TECHNICAL INFORMATION

SUBJECT: Pulse Motor/Cement Resistor

MODEL: 2700

Dated: 1/8/88
Issue No: T-8

① WRITE PULSE MOTOR

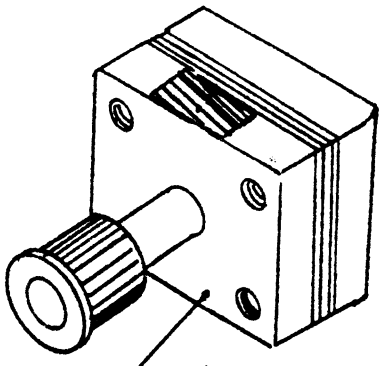
1. Write pulse motor part number 005-26000-102 Page II-38 Parts Book
2. Read pulse motor part number 005-26000-102 Page II-40 Parts Book
3. Cement Resistor MF 30A 200 JUL Page II-52 Parts Book
   Part No. 401-82000-002

Remember New Pulse Motor Part No. 005-26000-102 needs 20 OHM resistors. Do not use 30 OHM resistors with new pulse motors.

Pulse Motor

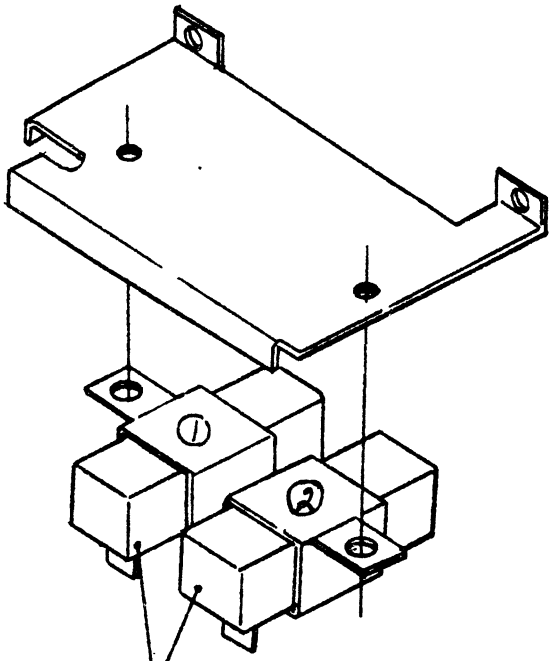
Machines manufactured from serial number 90410350, have a new type pulse motors (part number 005-26000-102). The new motors are designed to be quieter in operation and they are interchangeable. However; when using the new type motors on some of the previous machines, it may be necessary to change to the new type cement resistors part number 401-82000-002. The new resistor is 20 ohms versus the old type 30 ohms.

Cement Resistor

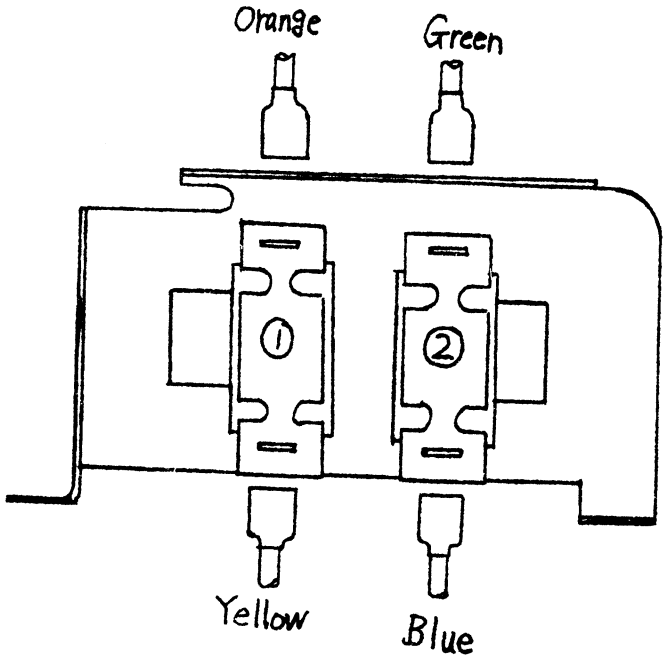
If you order a pulse motor you will receive the new type motor. To avoid weak power in the pulse motor the new 20 ohm resistor must be used. The reference list below should be used when ordering a pulse motor to ensure the proper resistor is used.
